**Federal Aviation
Administration**

**Design and Implementation Team
Technical Report**

Cleveland/Detroit (CLE/DTW) Metroplex

November 7, 2017

Figure 1. Final Design of the CLE TRYBE ONE STAR - enroute view

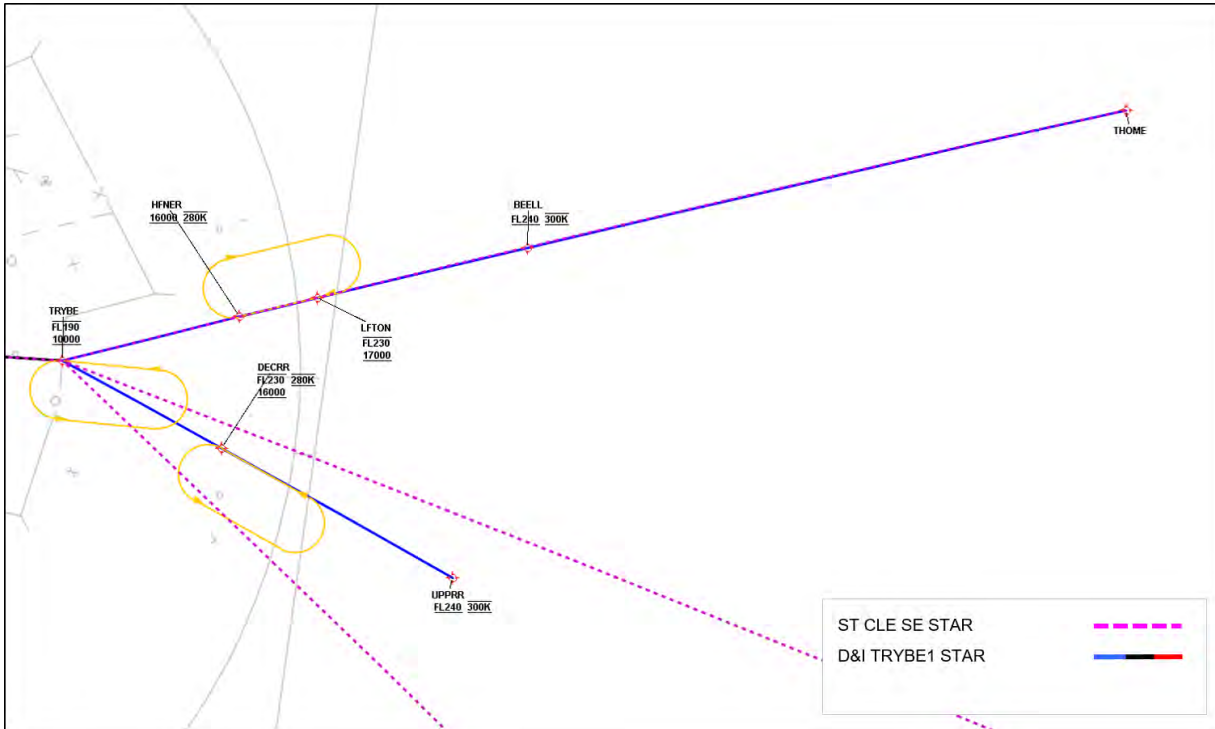
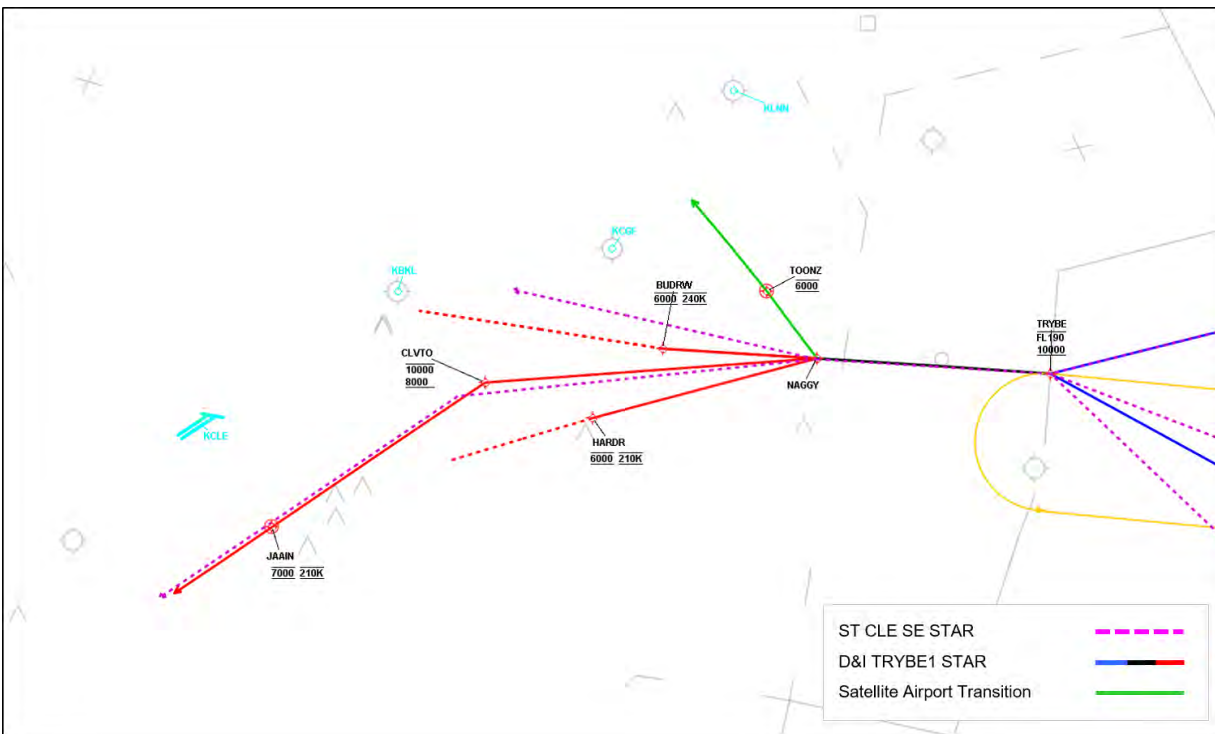
- Two enroute transitions from the southeast were combined into one transition
- Altitude restrictions were added to deconflict with New York area traffic
- RWY 24L/R transitions were moved south to shorten track miles
- Holding patterns added at TRYBE, HFNER and DECRR

Figure 3. Final Design of the CLE ROLLN ONE STAR - enroute view

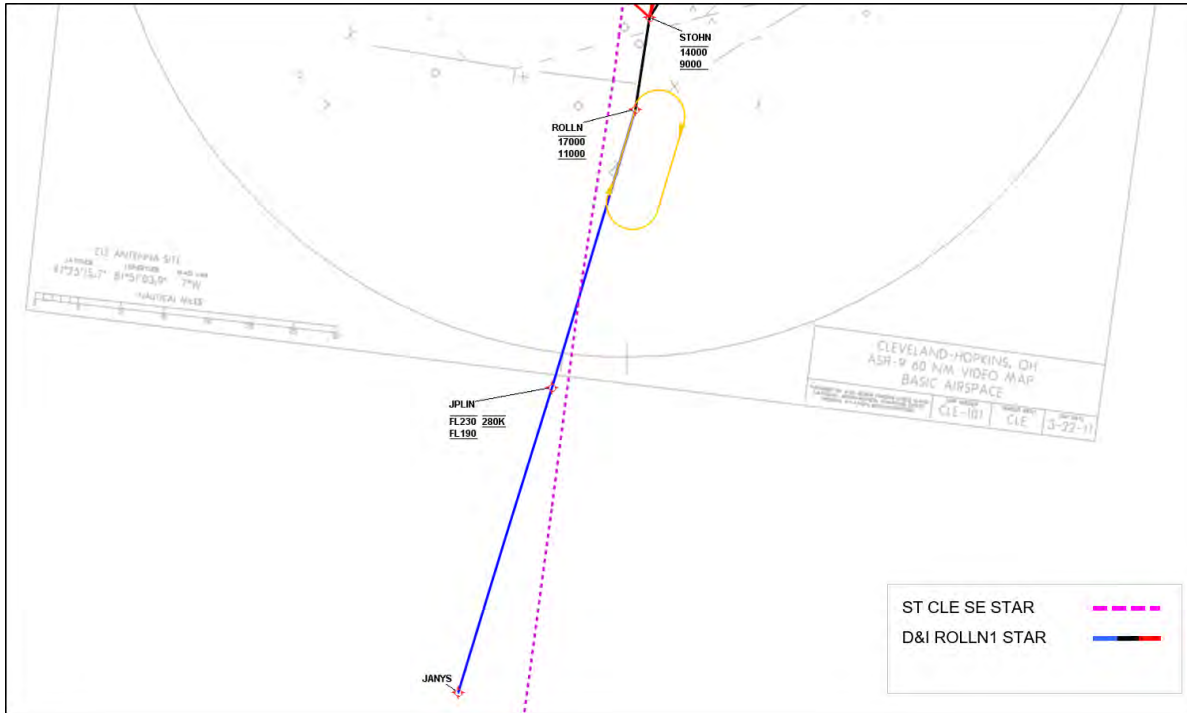
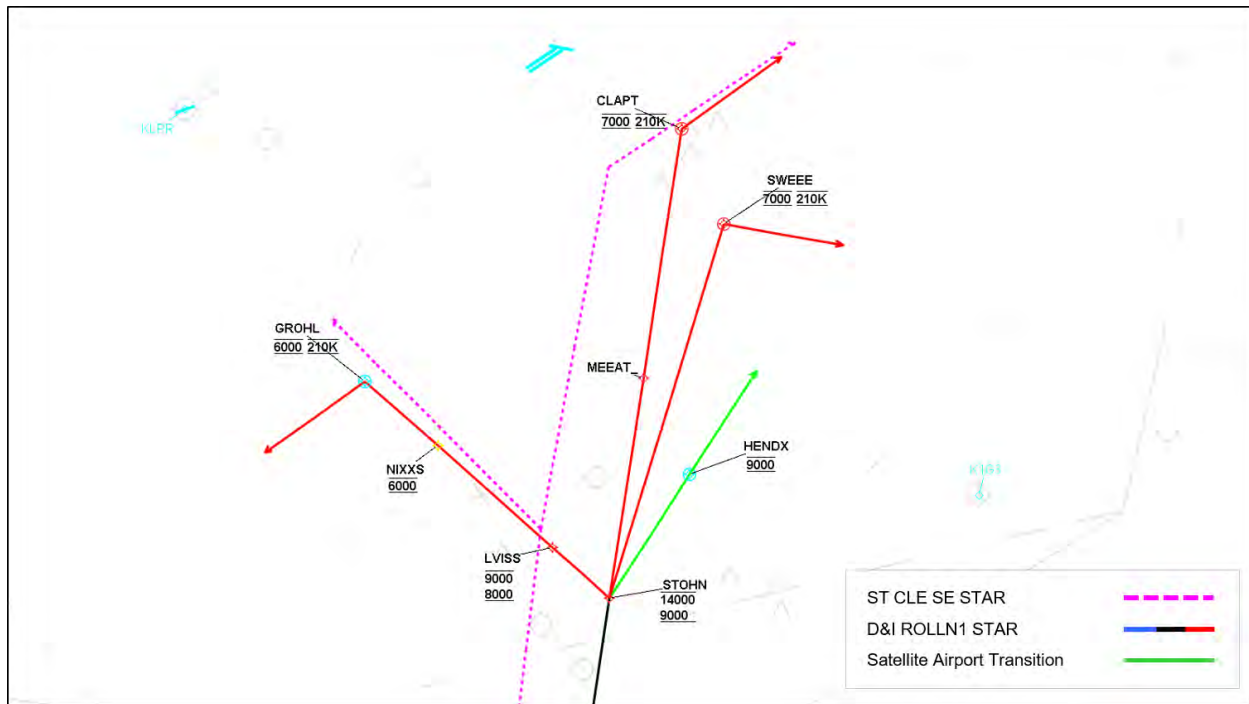
- Entry point was moved to the west to align with downstream fix
- Primary runway arrival track route has been moved to the east to favor the south flow
- Holding pattern added at ROLLN

Figure 5. Final Design of the CLE ROKNN ONE STAR - enroute view

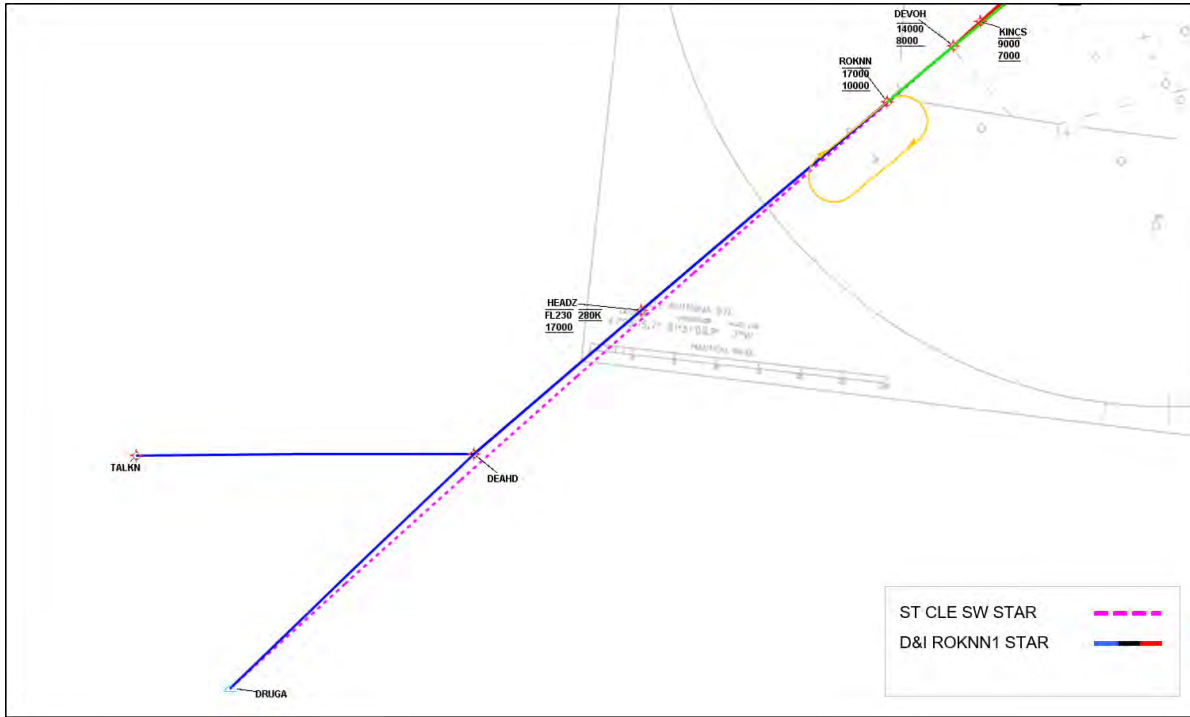
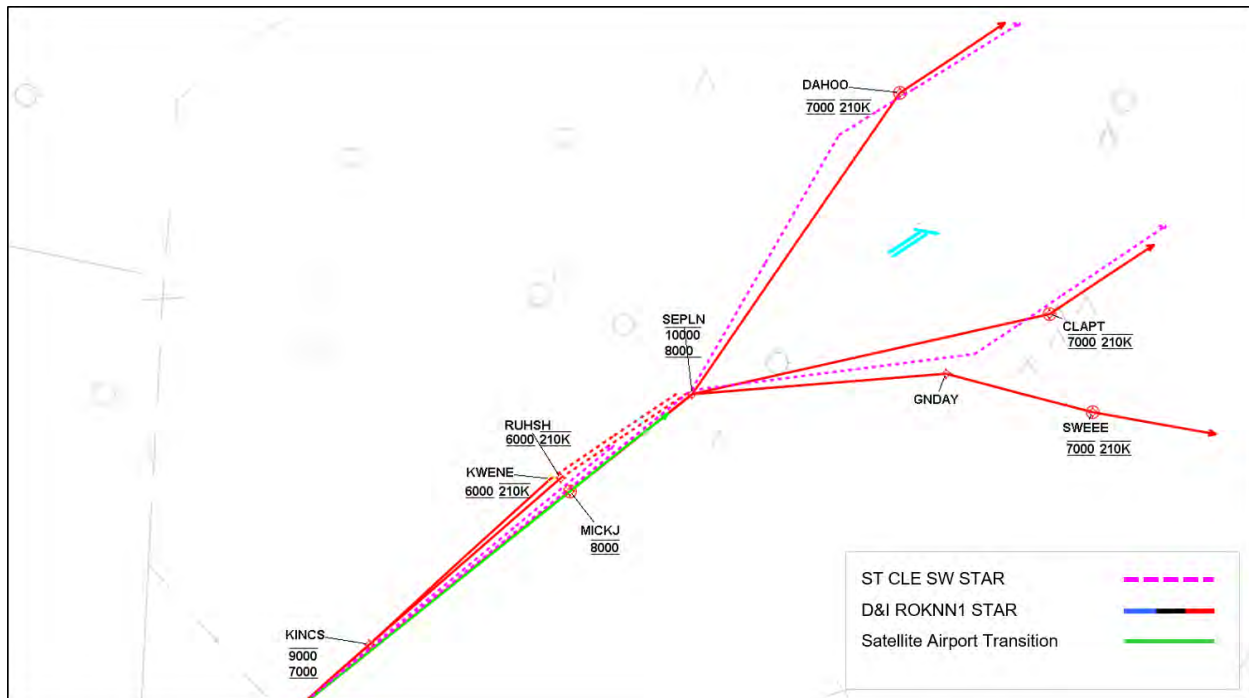
- Added fix DEVOH to keep aircraft within CLE approach airspace
- Holding pattern added at ROKNN

Figure 7. Final Design of the CLE BRWNZ ONE STAR - enroute view

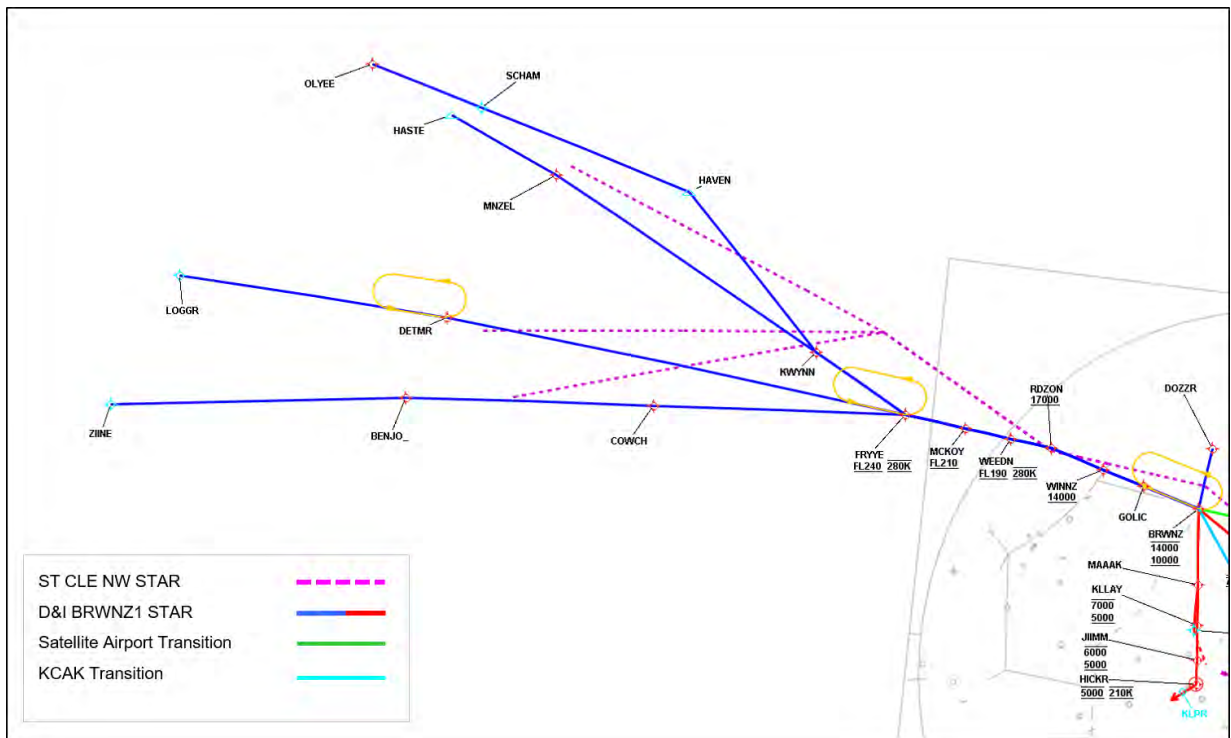
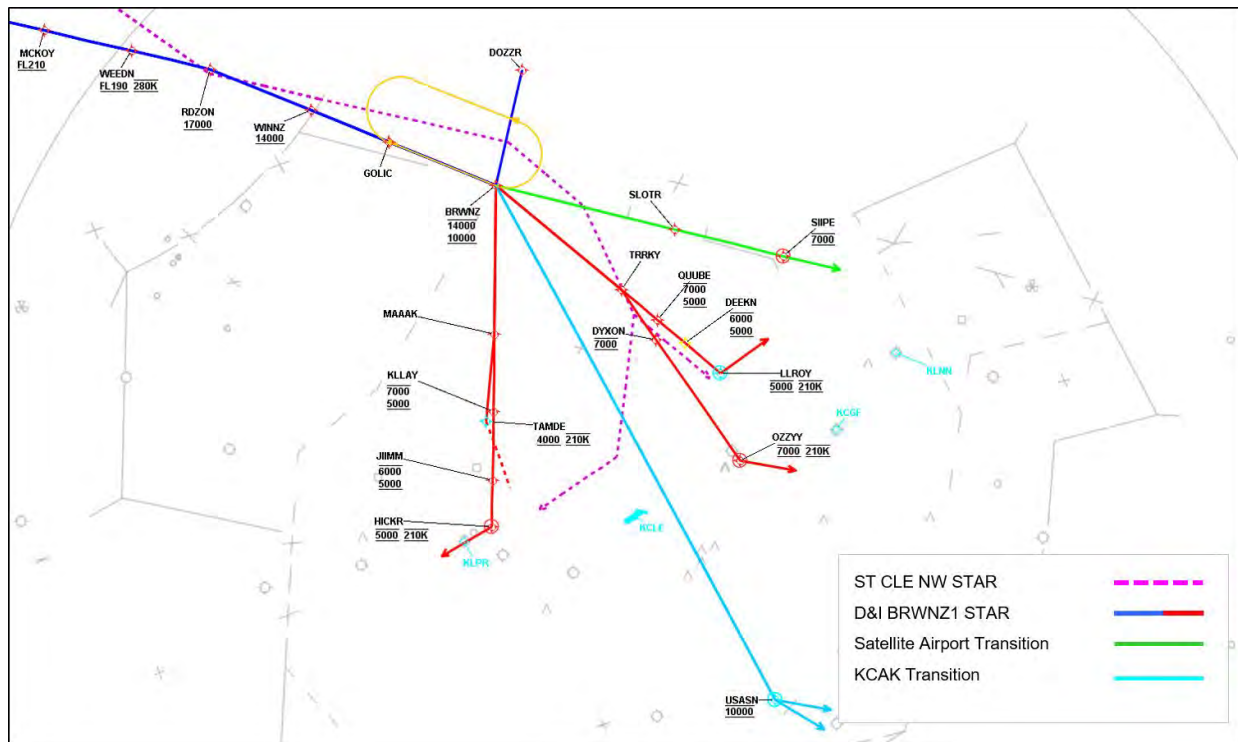
OAPM Design Package Change Control Sheet			
Date	Description	TARGETS File Reference	FAA/NATCA Co-Lead Initials
20170309	<p><u>CLE BRWNZ STAR</u></p> <p>) Changed waypoint DOZZR to DOZRR. Purpose: DOZZR waypoint name not reserved, DOZRR was reserved.</p>	20171107_CLE_DTW_MASTER_FINAL.tgs	RW / MT
20170309	<p><u>CLE BRWNZ STAR</u></p> <p>) Moved BENJO 0.355 NM north to 415308.45N/0851233.15W Purpose: To Correct the location of the waypoint in the NFDC per Instrument Flight Procedures Group Team 1. Submit corrected 8260-2 to correct position in AIRNAV2 database.</p>	See above.	RW / MT
20170512	<p><u>CLE ROLLN STAR</u></p> <p>) Deleted Altitude/Speed at JPLIN.) Added new waypoint GEDDY 3NM south ZID/ZOB boundary on current ground track at N40 32 11.21 W81 49 35.66) Added 170B230/280K at new waypoint GEDDY. Purpose: Restriction moved to be effective after ZOB clears flight for OPD.</p>	See above.	RW / MT

- Route moved south and closer to current HIMEZ route reducing track miles
- Merge point of enroute transitions (FRYYE) moved east and south to reduce track miles for primary transitions (ZIINE and LOGGR)
- Runway transitions track towards a base-leg entry at JIIMM and DEEKN (vs. downwind) to reduce track miles
- Added transitions for CLE Runways 10 & 28, satellite airports, and CAK
- Replaced VOR entry points with waypoints
- Added holding patterns at BRWNZ, FRYYE and DETMR

Figure 2. Final Design of the AHMET ONE SID

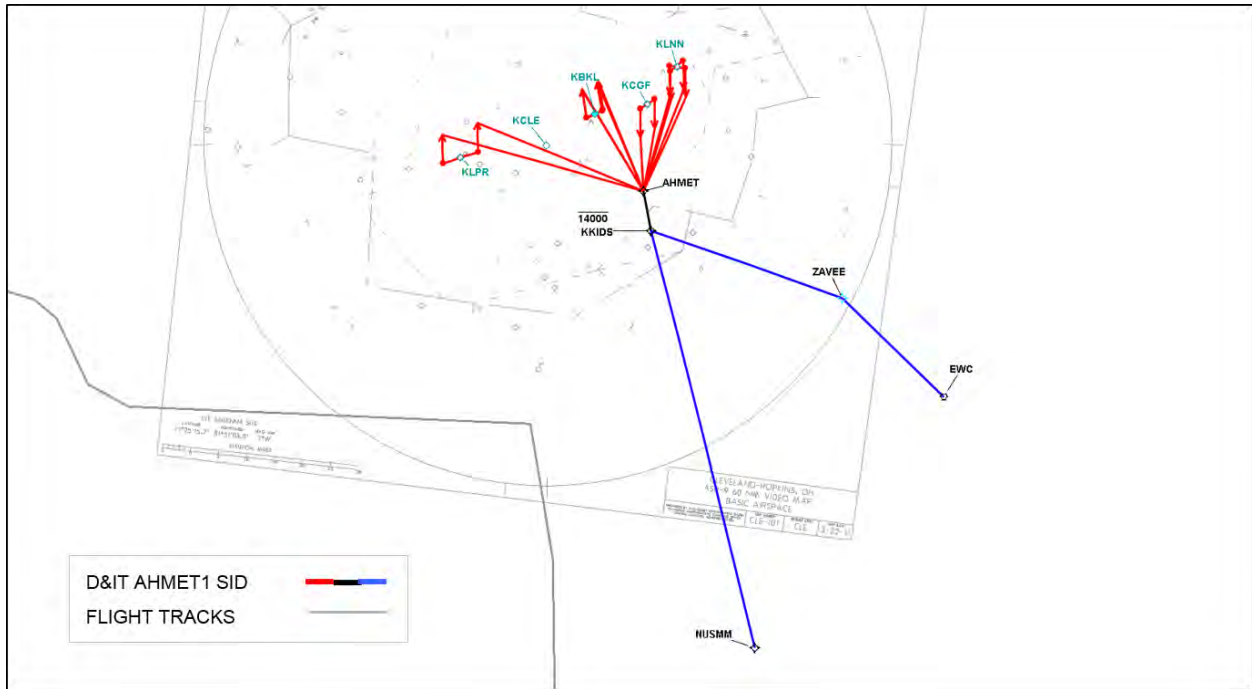
OAPM Design Package Change Control Sheet			
Date	Description	TARGETS File Reference	FAA/NATCA Co-Lead Initials
20170724	BKL AHMET SID) Added AOA30 at AHMET Purpose: To correct a criteria failure for required minimum or mandatory altitude at the IDF for SIDs with a radar vector component.	20171107_CLE_DTW_MASTER_FINAL.tgs	RW / MT
20170724	BKL MYCAR SID) Added AOA30 at OCIFR Purpose: To correct a criteria failure for required minimum or mandatory altitude at the IDF for SIDs with a radar vector component.	See above.	RW / MT

Figure 1. Final Design of the CAK HUUVR ONE STAR – Enroute View

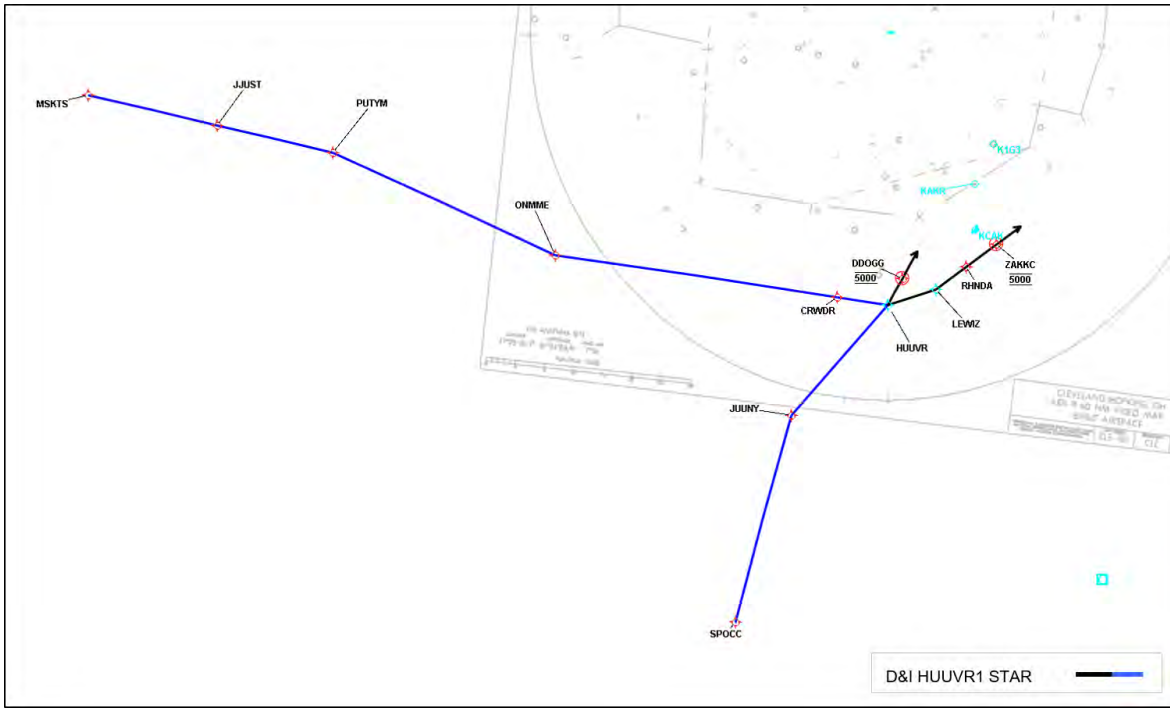
OAPM Design Package Change Control Sheet			
Date	Description	TARGETS File Reference	FAA/NATCA Co-Lead Initials
20171024	KCAK HUUVR STAR: J Added LAYES waypoint on the track between JUUNY and HUUVR in ZID airspace 3.0 NM from the ZOB/ZID boundary Purpose: Coordination waypoint for ZOB and ZID needed.	20171107_CLE_DTW_MASTER_FINAL.tgs	RW / MT

Figure 1. Proposed Final Design DTW ZETTR ONE SID – Terminal View

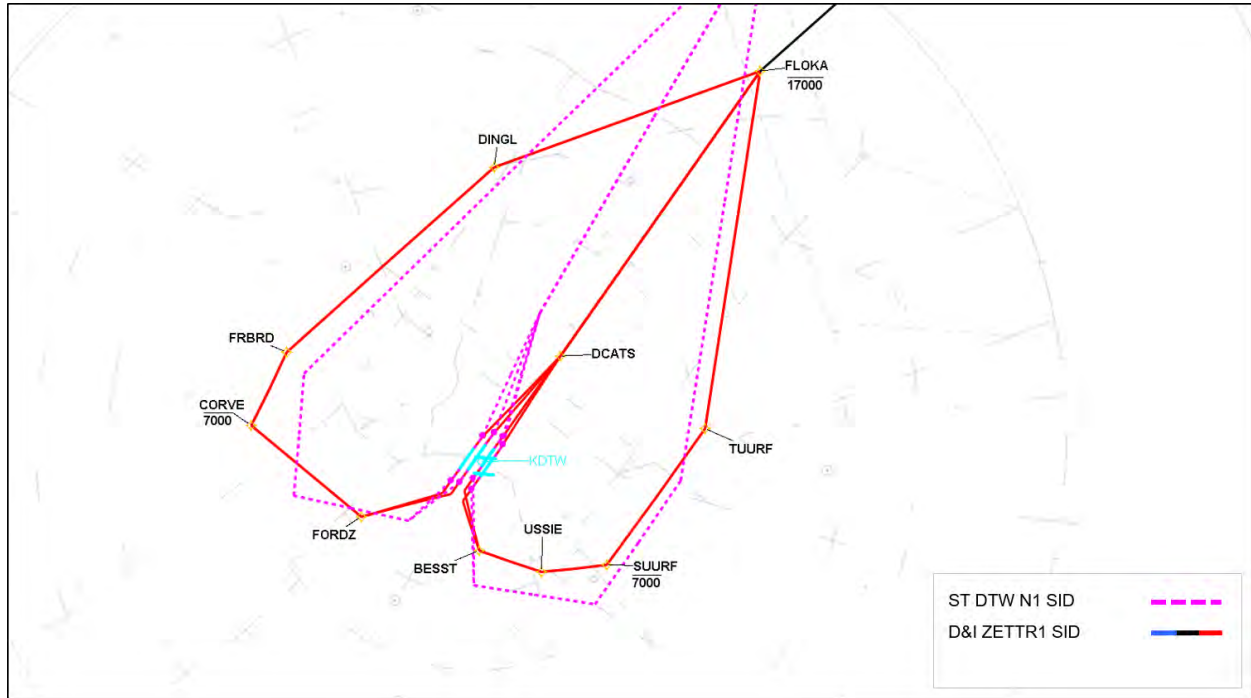
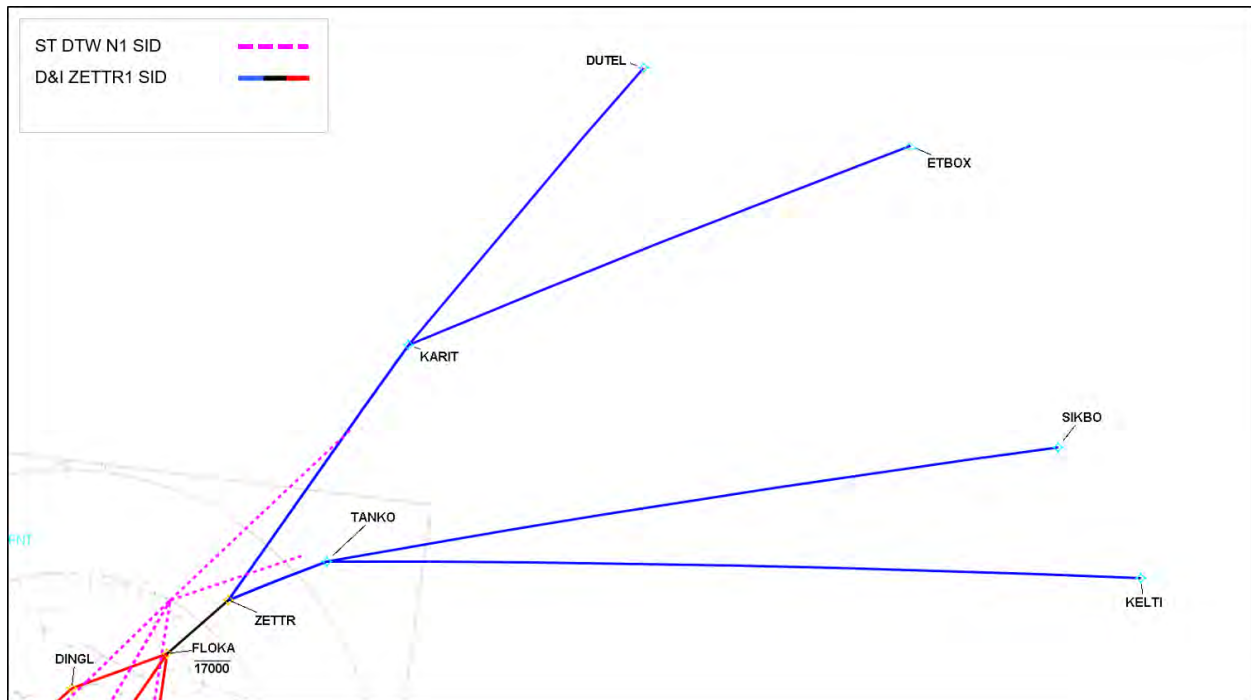
20170724	<u>DTW ZETTR SID</u> J Added AOA40 at FLOKA, delete AOB170 at FLOKA, add AOB170 at ZETTR Purpose: To correct a criteria failure for required minimum or mandatory altitude at the IDF for SIDs with a radar vector component.	See above.	RW / MT
20170724	<u>DTW ZETTR SID</u> J Renamed BESST waypoint to WINRS Purpose: To avoid confusion between WINGZ and WINRS (requested by DTW ATCT).	See above.	RW / MT
